PROJECT TITLE: Division of Vocational Rehabilitation Addition

**RE: DIVISION OF VOCATIONAL REHABILITATION ADDITION (G16-D57C). DRAINAGE
REPORT FOR BUILDING PERMIT APPROVAL. ENGINEER'S STAMP DATED 3-6-98.**

**RE: DIVISION OF VOCATIONAL REHABILITATION ADDITION (G16-D57C). DRAINAGE
REPORT FOR BUILDING PERMIT APPROVAL. ENGINEER'S STAMP DATED 1-5-98 (SHEET
C2) AND 1-13-98 (SHEETS DB1 AND DB2).**

**RE: DRAINAGE REPORT AND GRADING AND DRAINAGE PLAN
DIVISION OF VOCATIONAL REHABILITATION ADDITION (G16-D57C)
ALBUQUERQUE, NEW MEXICO**

94 GPM (0.21 cfs)

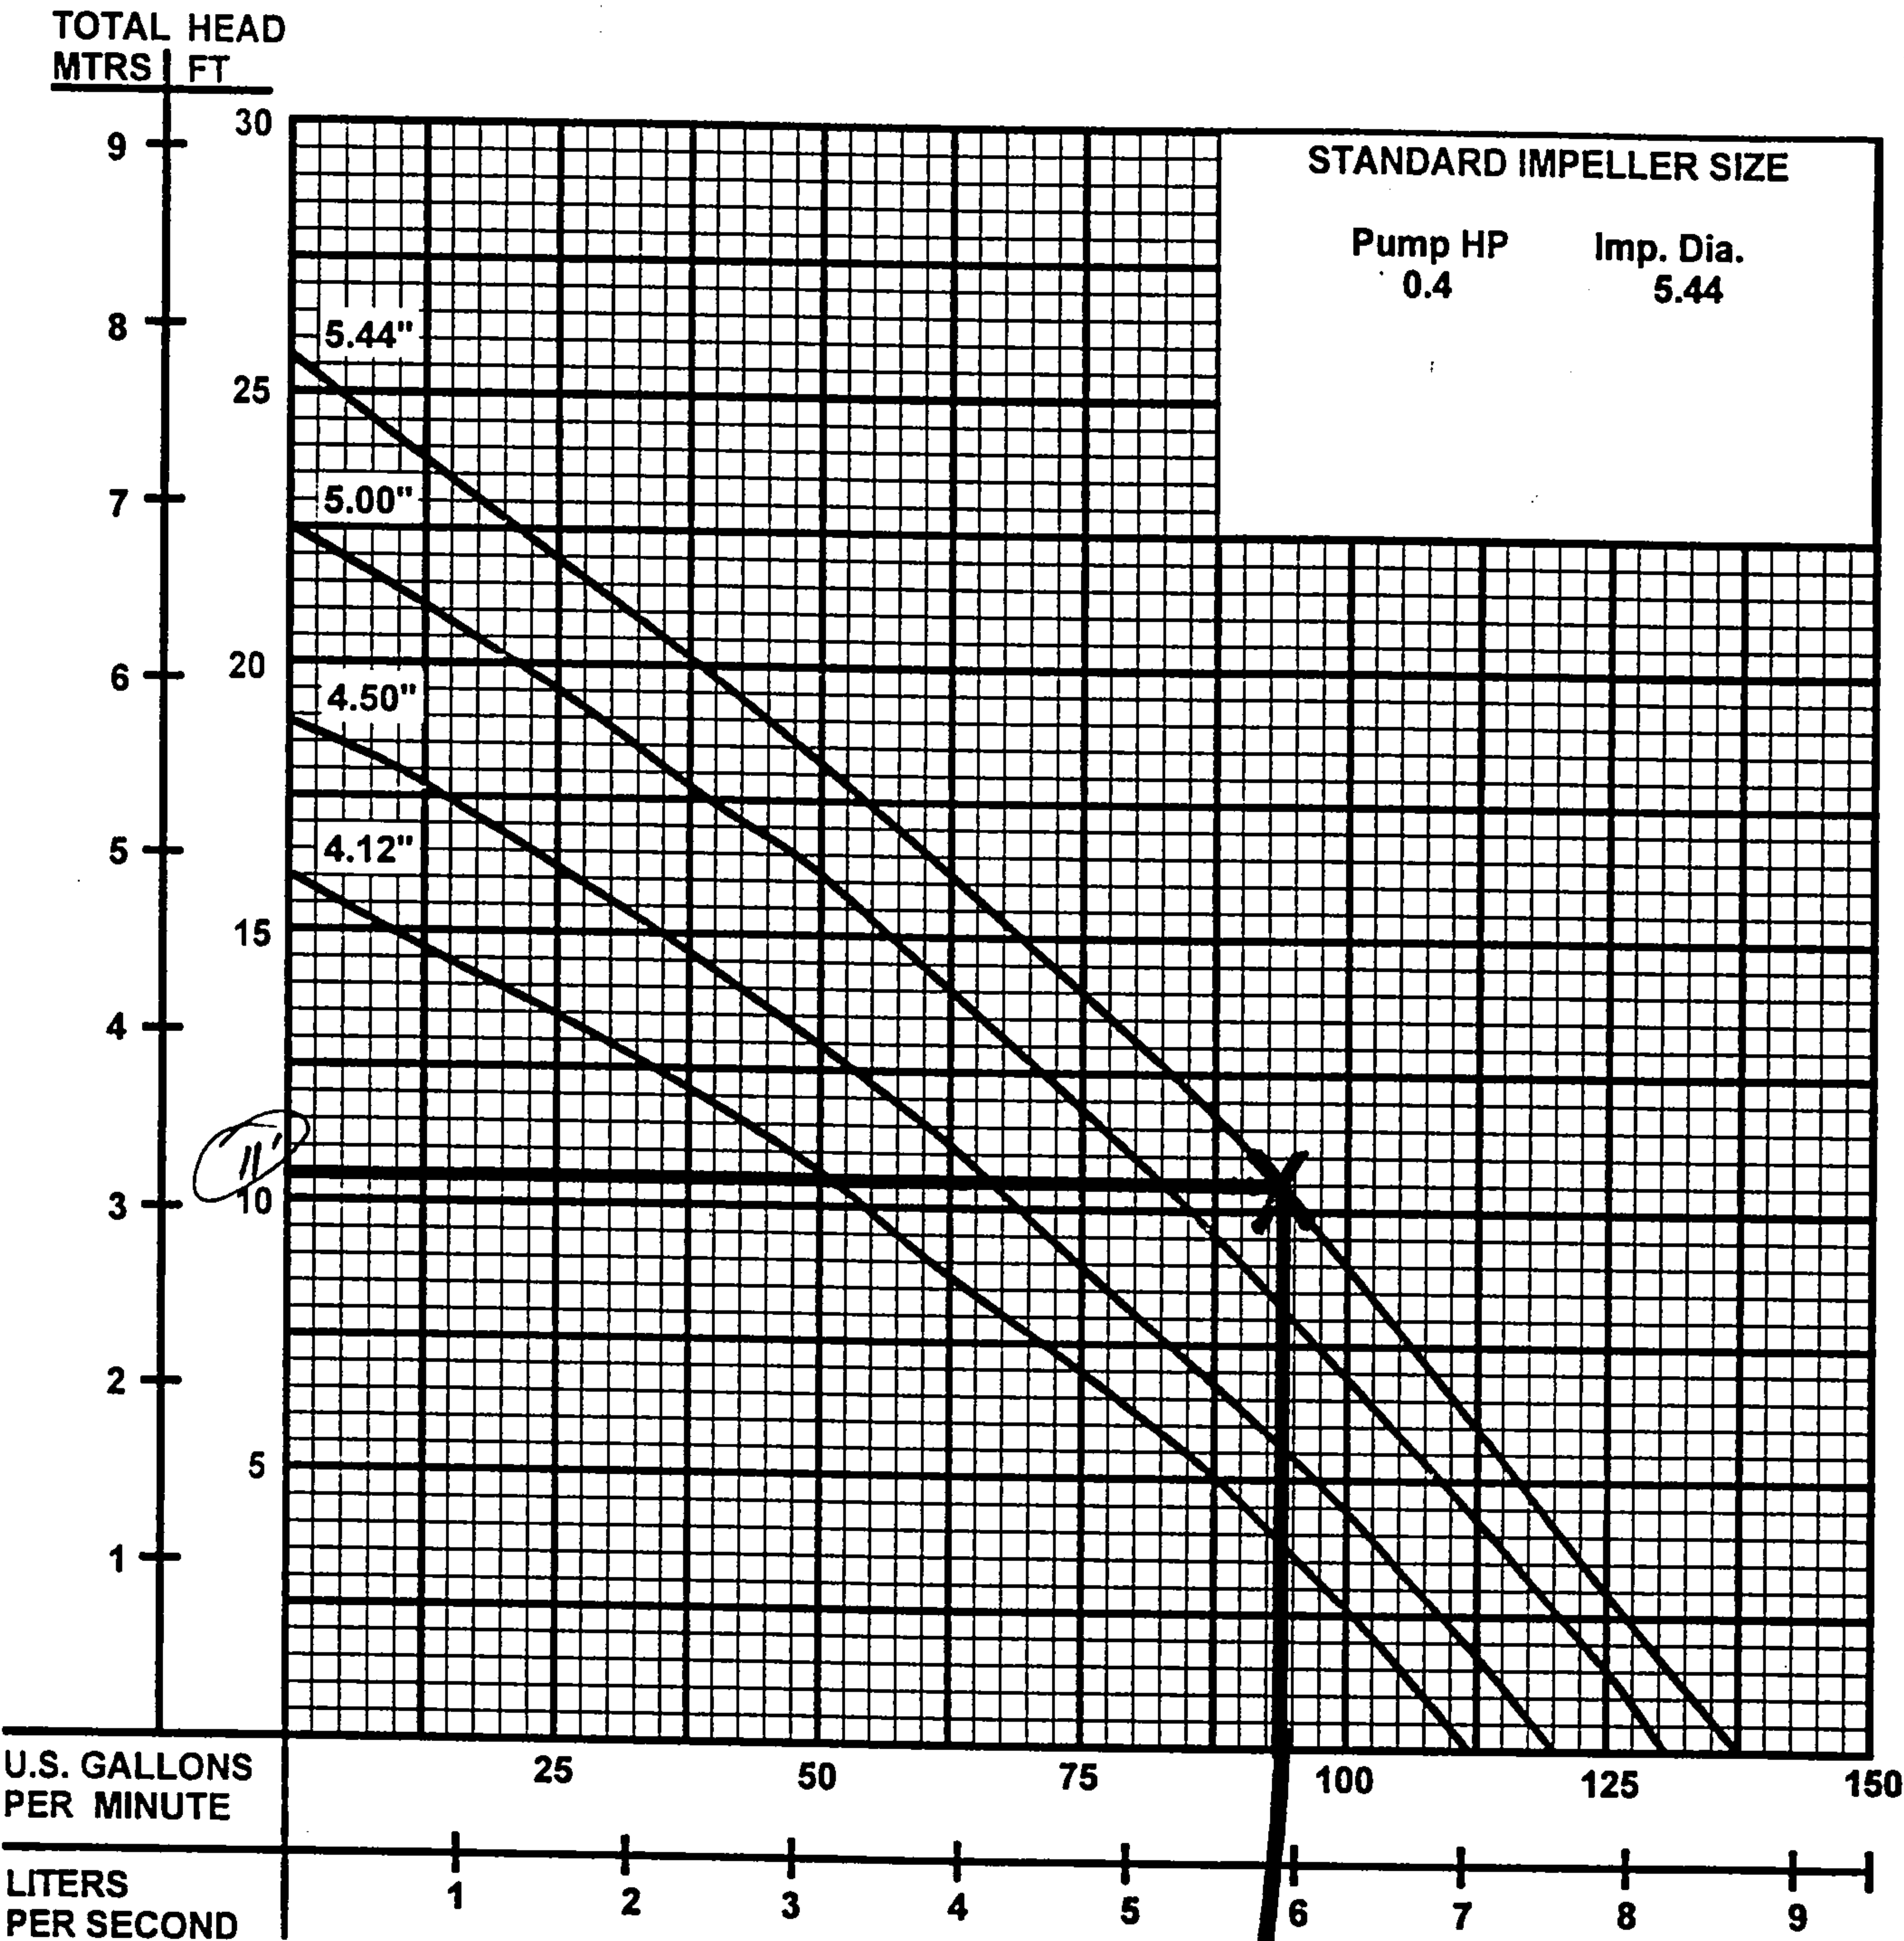
well, is that
capacity? provide
applicable info.
